DESIGN <i>[Signature]</i>	DRAWN BY <i>[Signature]</i>	DART AEROSPACE LTD HAWKESBURY, ONTARIO, CANADA	
CHECKED <i>[Signature]</i>	APPROVED <i>[Signature]</i>	DRAWING NO. DSI 9239	REV. A SHEET 1 OF 1
DATE 02.08.27		TITLE BASKET MODIFICATION	SCALE NTS
A	02.08.27	NEW ISSUE

DART SERVICE INSTRUCTION

TO AMEND INSTALLATION DRAWING D350-607 REV. E

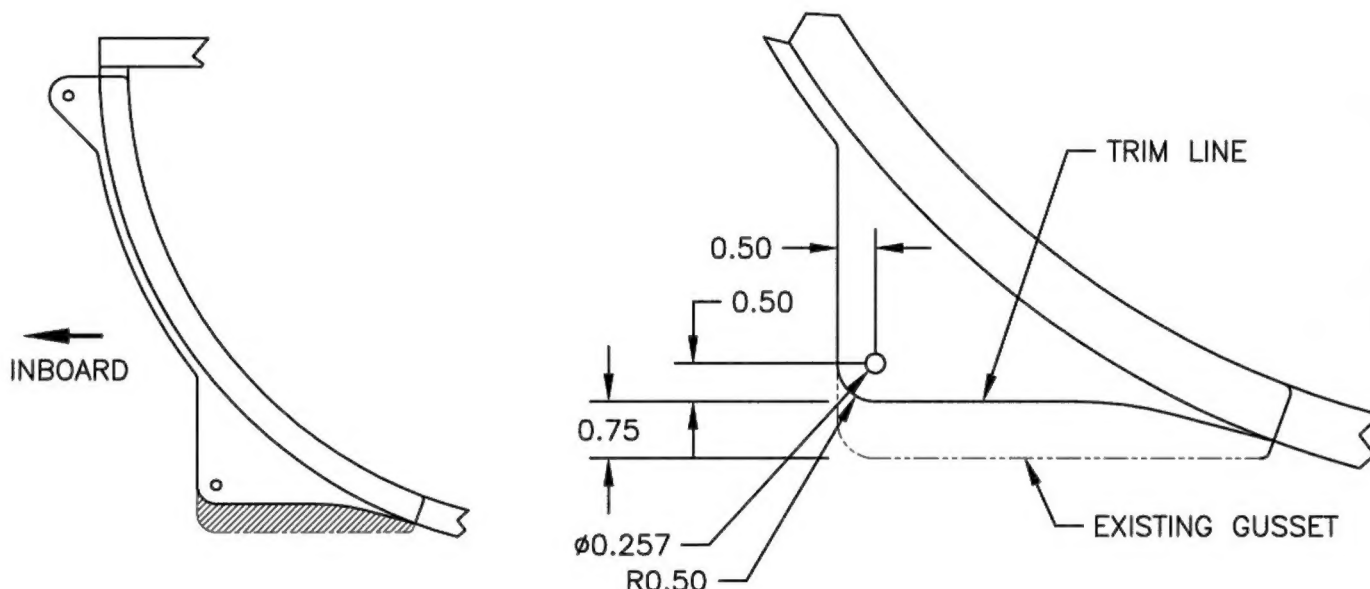
TO IMPROVE COMPATIBILITY WITH OTHER KITS (ie. DART D350-591 STEPS AND D350-600 SPACEPODS), IT IS ACCEPTABLE TO MODIFY THE SUPPORT GUSSETS ON D350-607-041/-042 (CHANGE 005 OR EARLIER) OR D350-607-043/-044 (CHANGE 002 OR EARLIER) AS SHOWN BELOW:

1. REMOVE BASKET FROM AIRCRAFT.
2. TRIM GUSSET AS SHOWN.
3. DRILL $\varnothing 0.257$ HOLE AS SHOWN.
4. DEBURR AND TOUCH-UP FINISH.
5. REINSTALL BASKET.
